**Report: Deficiency Report
Function: Test, Adjust, & Balance
Date: 03/09/2026
Completed By: National TAB**

**PROJECT
03-09-26 QT #1022 KANNAPOLIS, NC**

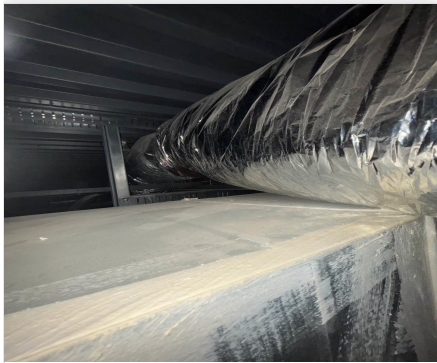
Issue Name : RTU 3 condenser fans in alarm
Description : The VFD controlling the condenser fans is in alarm. It is an oL 1. The unit is able to run cooling.
Created By : National TAB **Assigned To :** National TAB - Dan Hertenstein
Status : Open
Priority : High **Asset Tag :** RT-3
Originated Date : 03/09/2026 - Christian Moller - National TAB

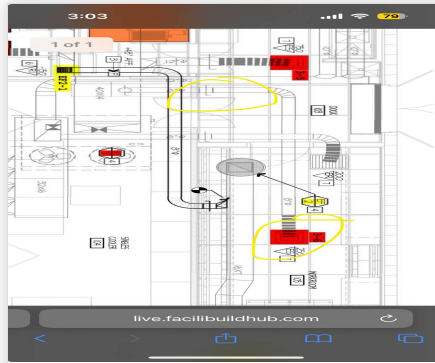
Issue Name : RTU 3 SGRD 6 damper unreachable
Description : the damper for SGRD 6 (work room) is unreachable. The branch runs directly toward and over the cooler instead of how plans describe. The diffuser is at 140% of design, which if dampened would bring the cookline diffusers (SGRD 1&2) into design.
Created By : National TAB **Assigned To :** National TAB - Dan Hertenstein
Status : Open
Priority : High **Asset Tag :** SGRD6
Originated Date : 03/09/2026 - Christian Moller - National TAB
